Service Bulletin # CS-51 Sub-1

Problem : The regulator IC's tend to overheat, eventually causing defective solder joints.

Service Bulletin # **CS-51 Sub 299** Page 1 of 2 Serial Number: All Date: 02/04/99

Problem: Voltage Regulator Transistors Q1, Q10 overheat. They or their solder joints eventually fail. Output Transistors Q7, Q8 run too hot.

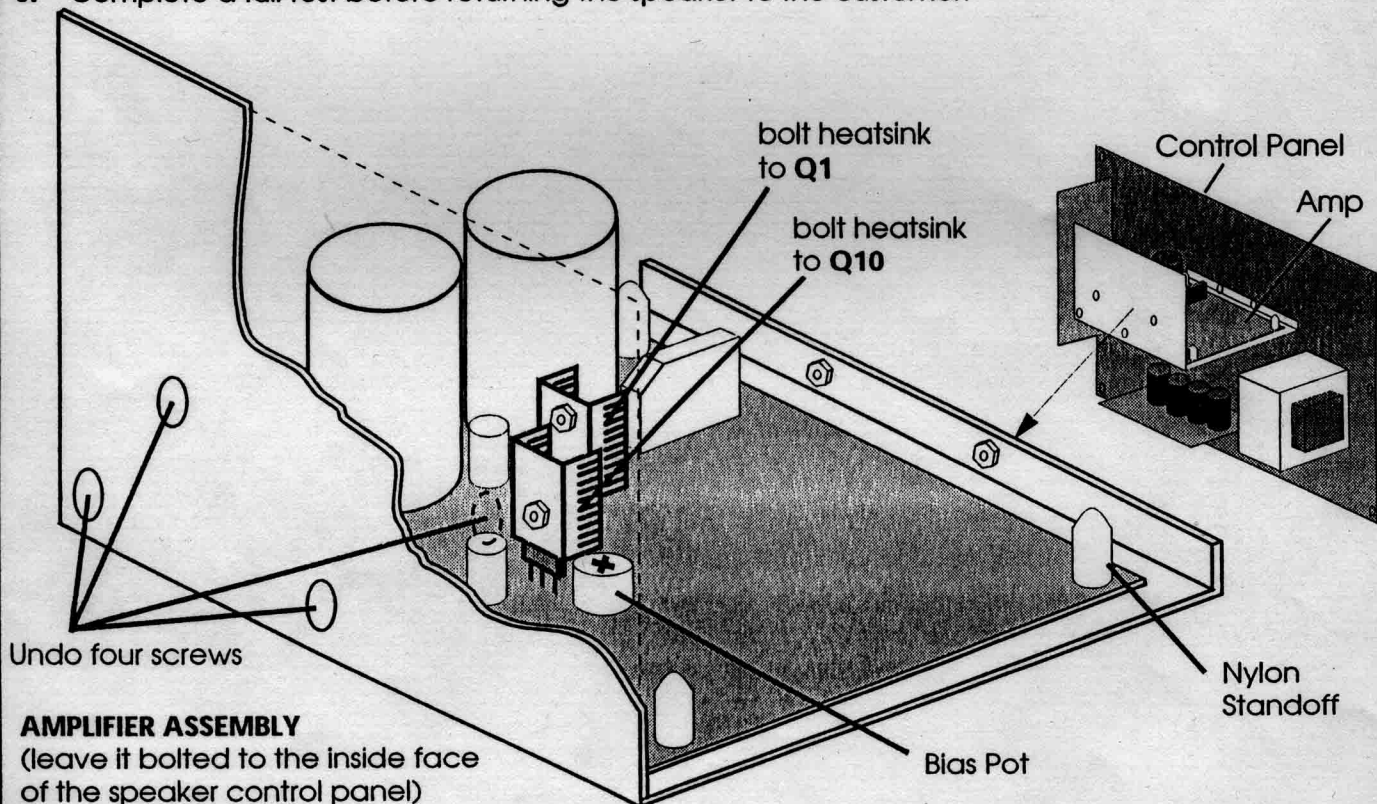
3. Touch up the solder joints on Q1 and Q10
4. Add a small heatsink to Q1 and Q10, using a lock-nut and screw. The heatsink for Q10 can be fitted upside down so it does not touch the Bias adjustment pot next to it.

5. **Make sure the heatsinks do not touch adjacent parts, especially the capacitors.**
6. Replace the amplifier board and tighten the four screws, making sure the main transistors Q7 and Q8 are secured to the main heatsink with their clips. Reconnect all wiring.

Solution : Touch up the solder joints and add a bolt-on heatsink to IC Q1 and Q10

you may need to trim the heatsink fins to clear existing parts. This can be done with a wire cutter.

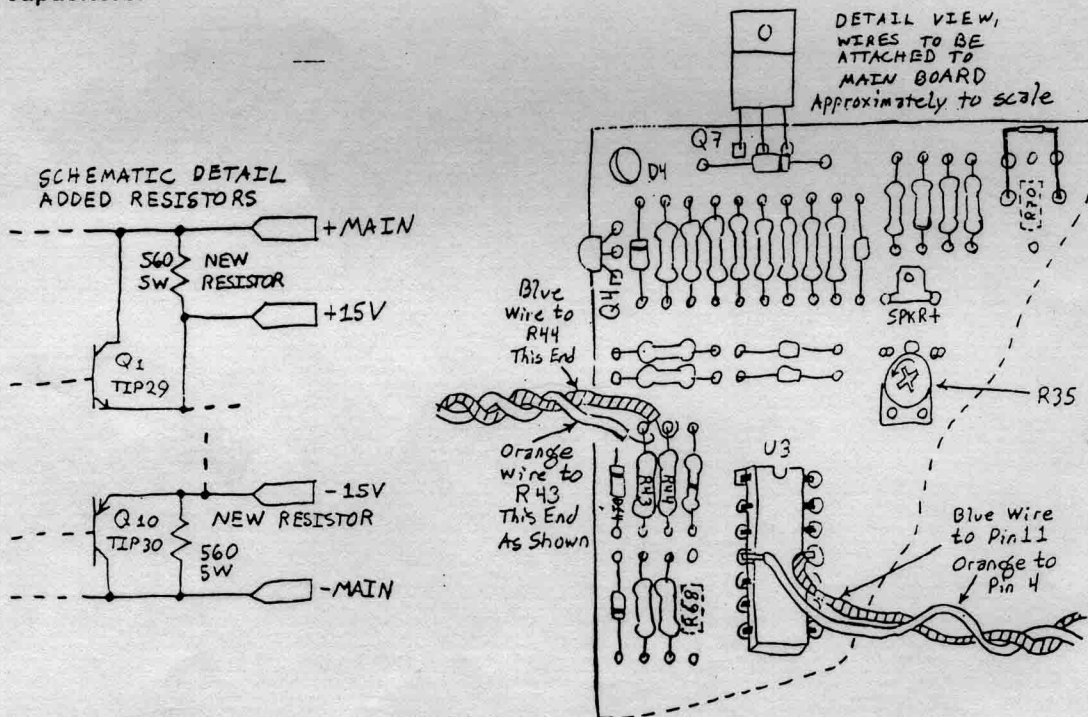
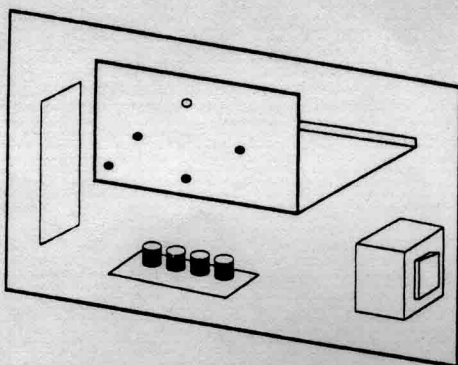
3. Touch up the solder joints on Q1 and Q10. Do not remove any heat sinks previously added to them.
4. Solder the wire assembly pairs to the appropriate locations on the circuit board as follows:
 Pair 1: Orange to U3 pin 4, Blue to U3 pin 11.
 Pair 2: Orange to R43's pin towards the main heatsink (which is next to D14's Cathode),
 Blue to R44's pin towards the heatsink (next to R43).
SEE DIAGRAM BELOW

Solution: Touch up the solder joints and add current-shunting resistors to Q1, Q10, and a larger Heat Sink.

Resistor Mounting Detail:

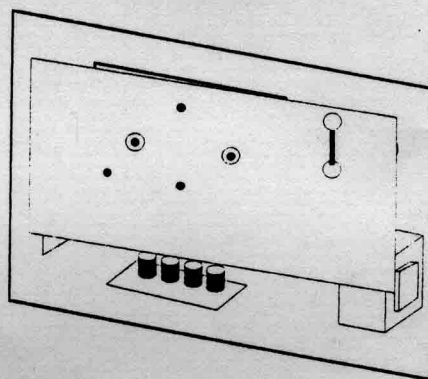
10. If the resistors are not already attached, apply RTV to them and to the new Heatsink Plate and tie-wrap the resistors to the appropriate location. Reconnect all wiring except the driver's. The RTV will secure the resistors after it dries.
SEE DIAGRAM BELOW

9. If not already attached, solder the wire pairs to the new power resistors: the two Orange wires (one from each pair) go to the two terminals of one resistor, and the two Blue wires go to the other resistor.
